**Davis Hall, Ground Floor Renovations**

**Project Number: SCSU-2023-02**

**ADDENDUM NO. 2**

**April 28, 2023**

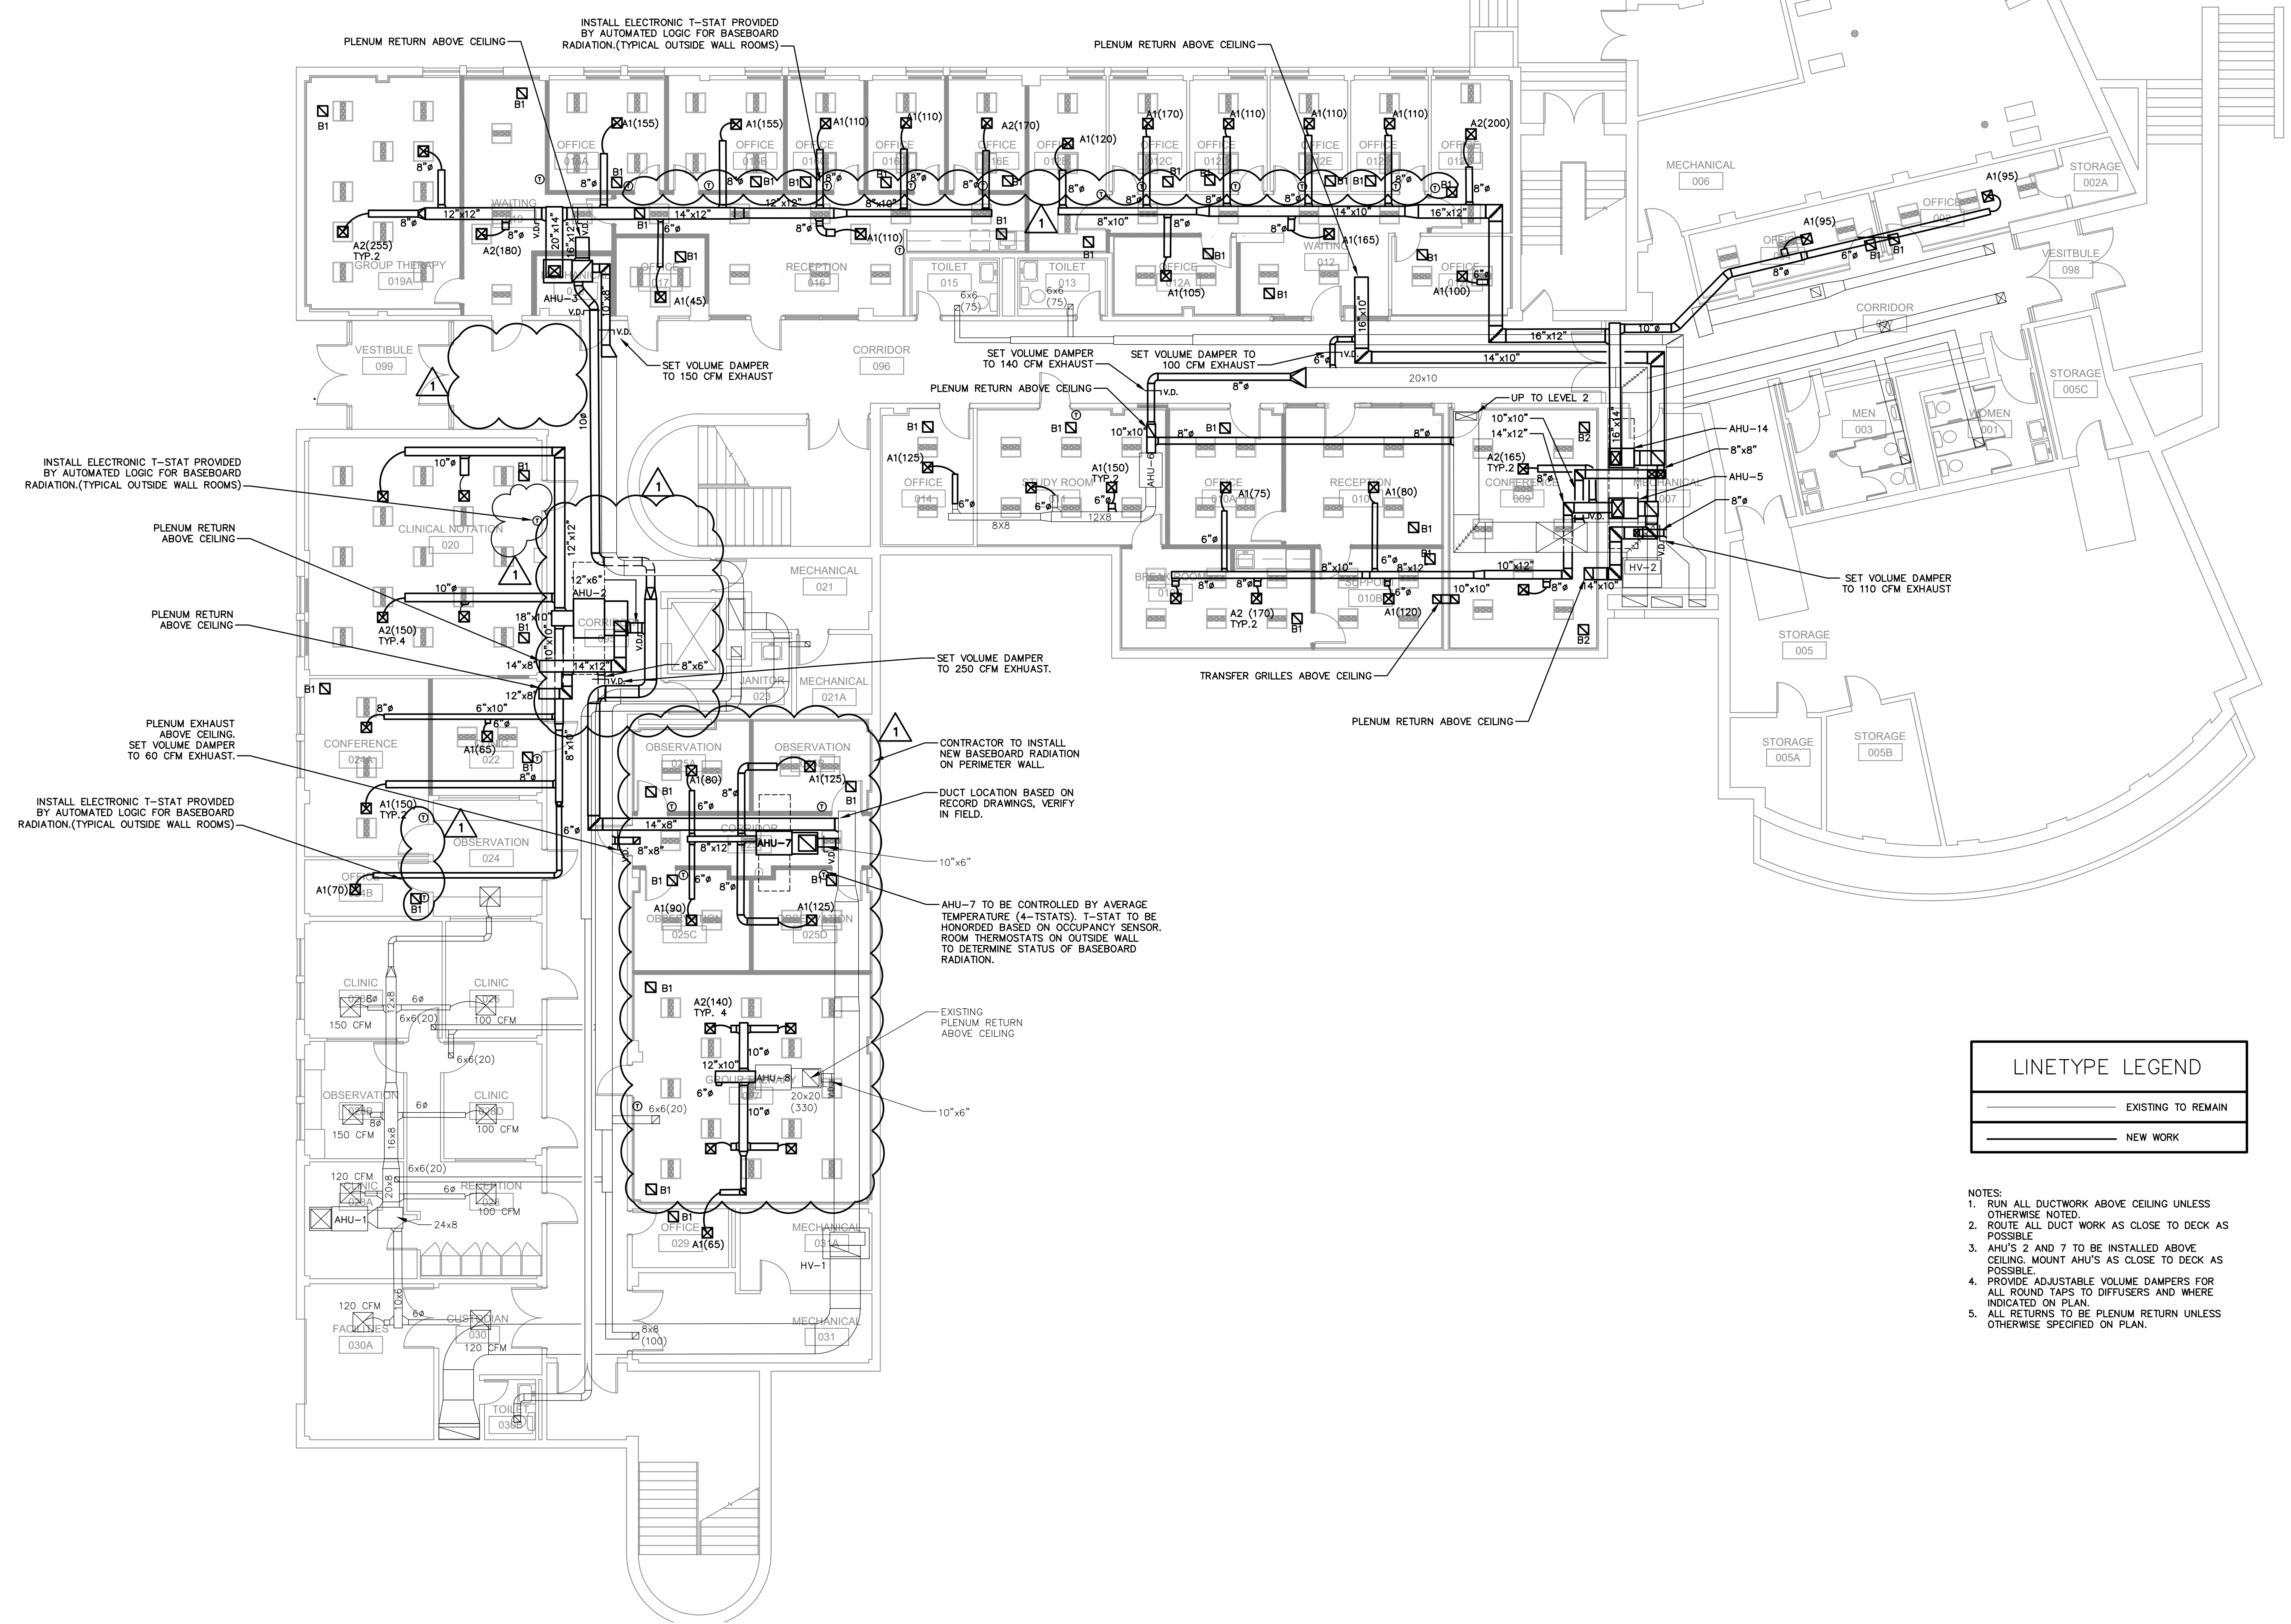
**Item 4 - DRAWING M1.01, AHU-7 CONTROLS:**

AHU-7 to be controlled by averaging thermostats (provided by Automated Logic) in rooms 025A, 025B, 025C, and 025D). Thermostats to be honored based on occupancy sensor status. Room thermostats (provided by Automated Logic) on outside walls to determine status of baseboard radiation.

**Item 5 - DRAWING M1.01, AHU-2 DUCTWORK:**

Relocate position of new AHU-2 to Corridor 095 between the elevator and Clinical Notation 020. See revised M1.01 drawing, attached, for new ductwork routing.

INSTALL ELECTRONIC T-STAT PROVIDED BY AUTOMATED LOGIC FOR BASEBOARD RADIATION.(TYPICAL OUTSIDE WALL ROOMS)

CONTRACTOR TO INSTALL NEW BASEBOARD RADIATION ON PERIMETER WALL.

AHU-7 TO BE CONTROLLED BY AVERAGE TEMPERATURE (4-TSTATS). T-STAT TO BE HONORED BASED ON OCCUPANCY SENSOR. ROOM THERMOSTATS ON OUTSIDE WALL TO DETERMINE STATUS OF BASEBOARD RADIATION.

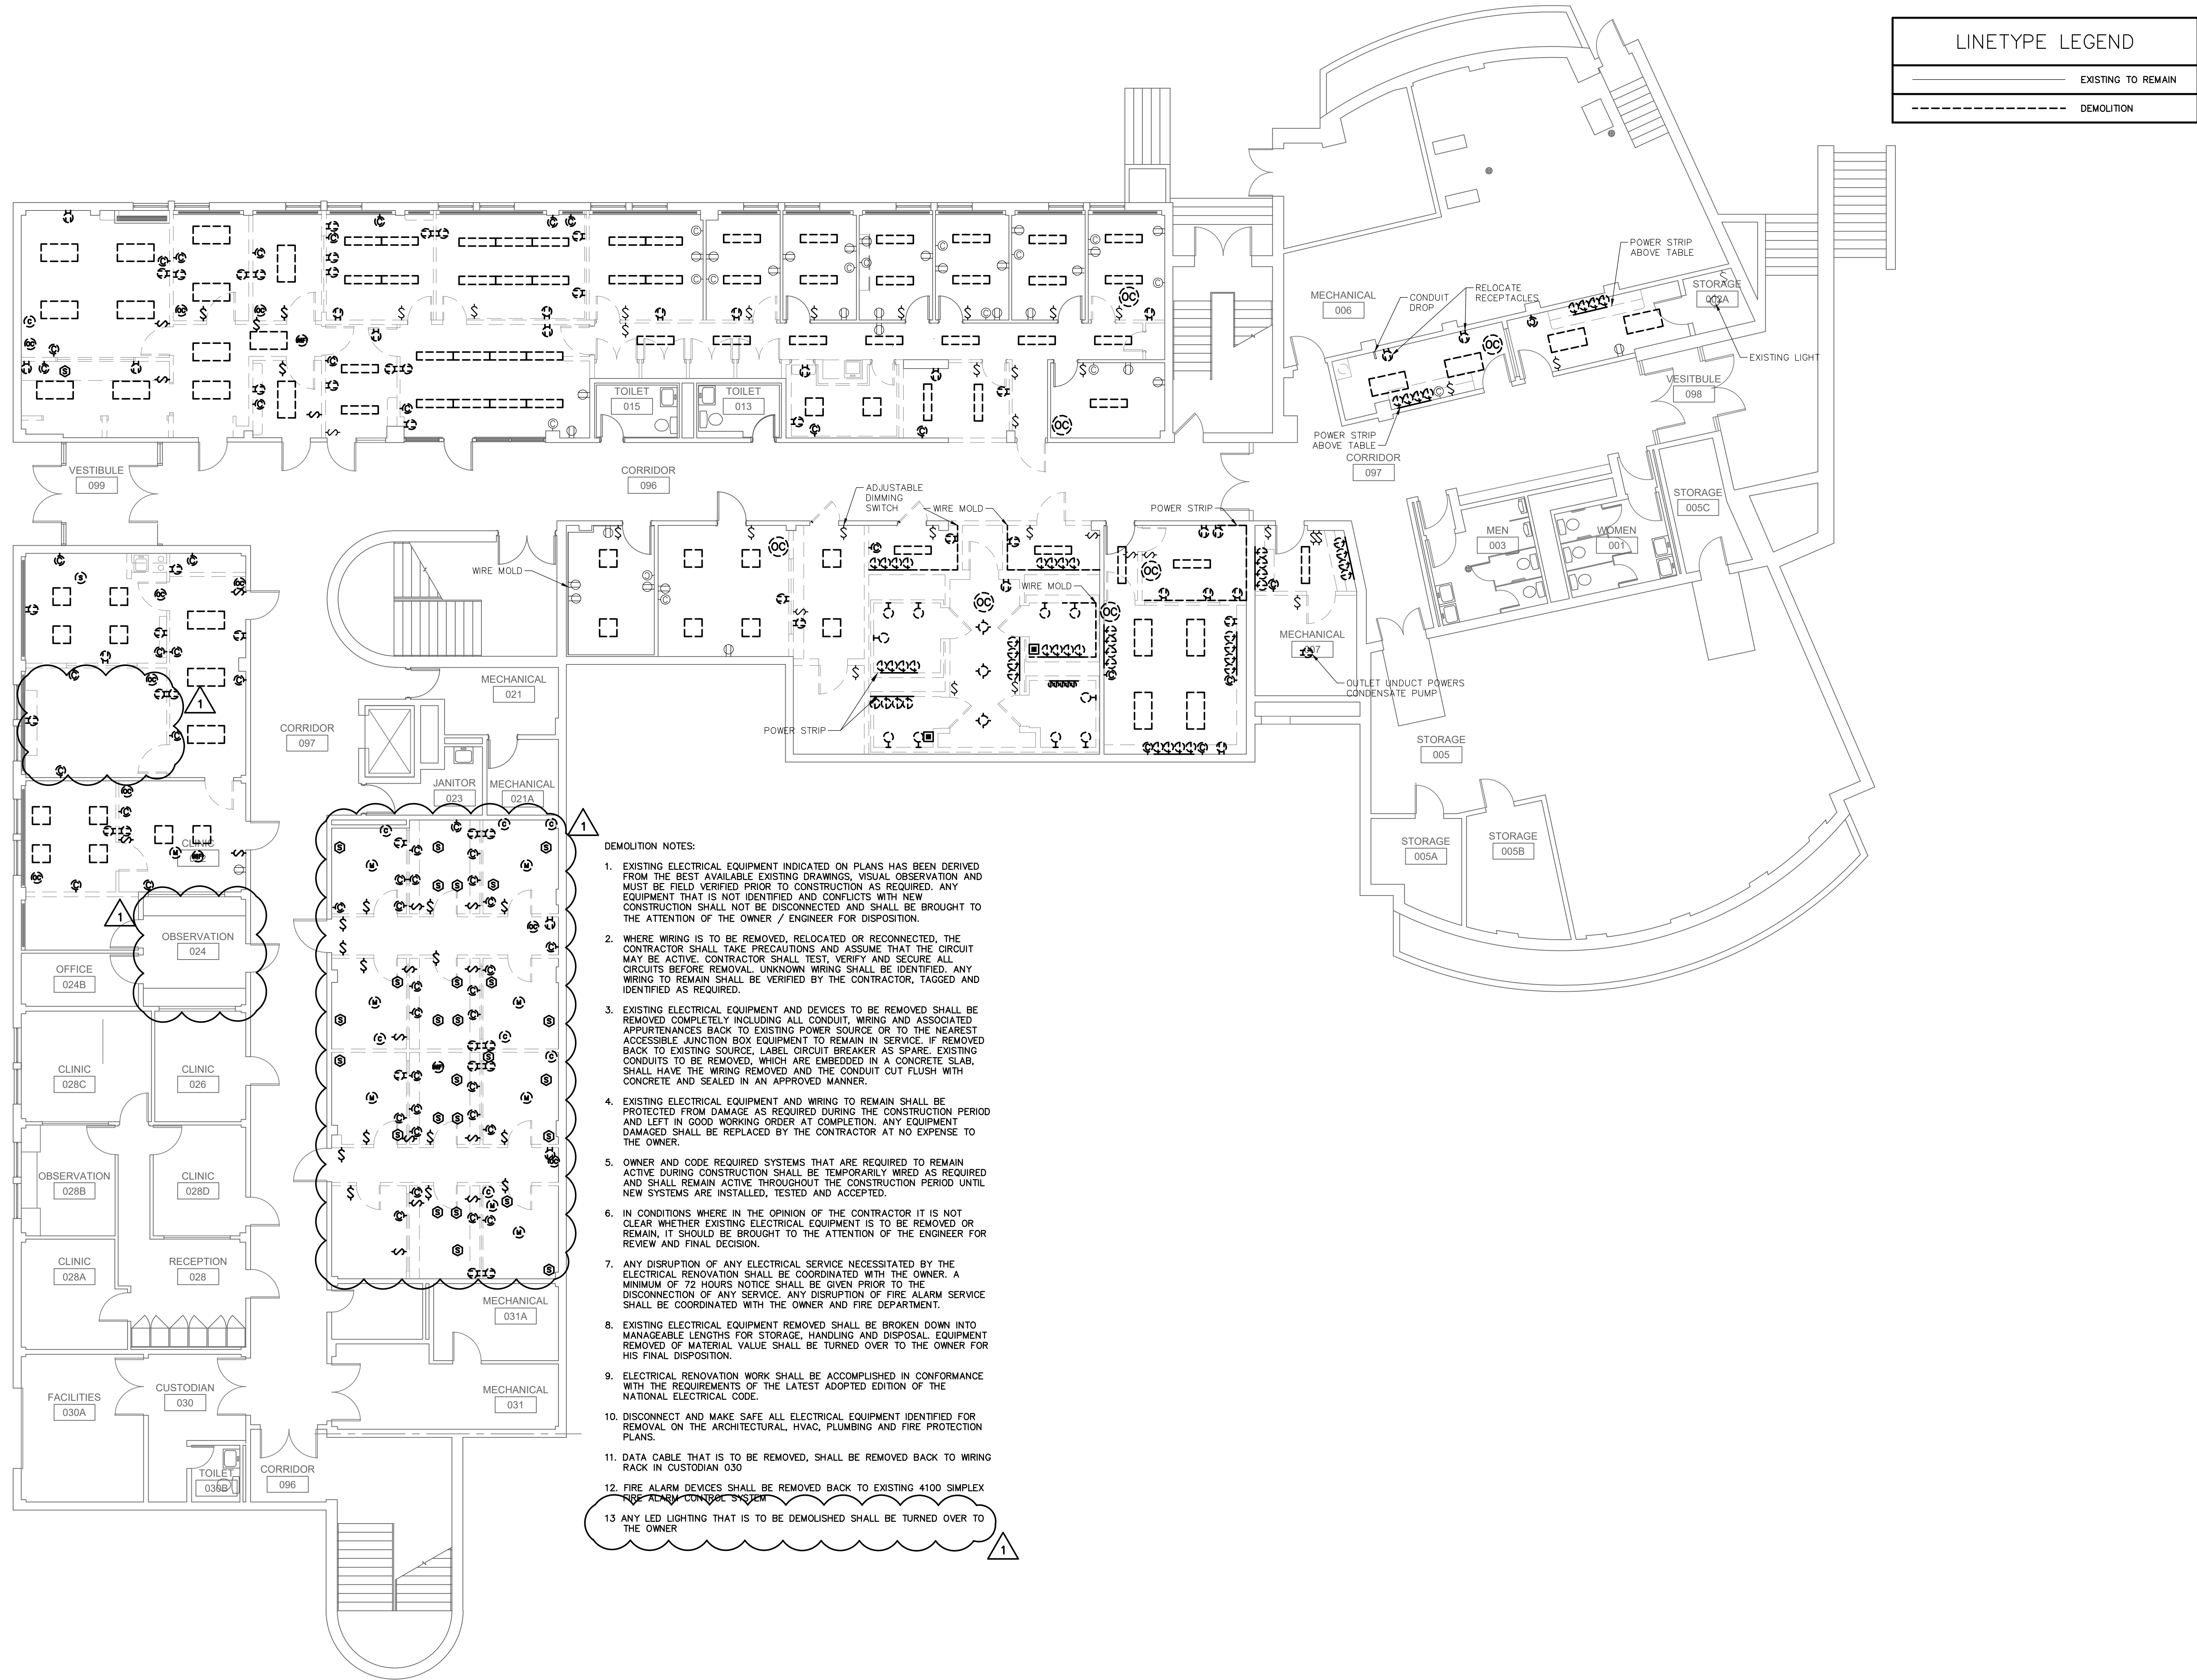
**Item 7 – DRAWING ED1.01, SCOPE REMOVAL:**

All lighting in Observation 025A-025D, Corridor 025, and Group Therapy 027 have been removed via hazmat abatement. Remove from scope.

**Item 8 – DRAWING ED1.01, SCOPE REMOVAL:**

Array lighting in Clinical Notation 020 has been removed via hazmat abatement. Remove from scope.

**Item 9 – DRAWING ED1.01, ADDITIONAL SCOPE:**

Remove two conduits in room 024A where wall has been demolished.
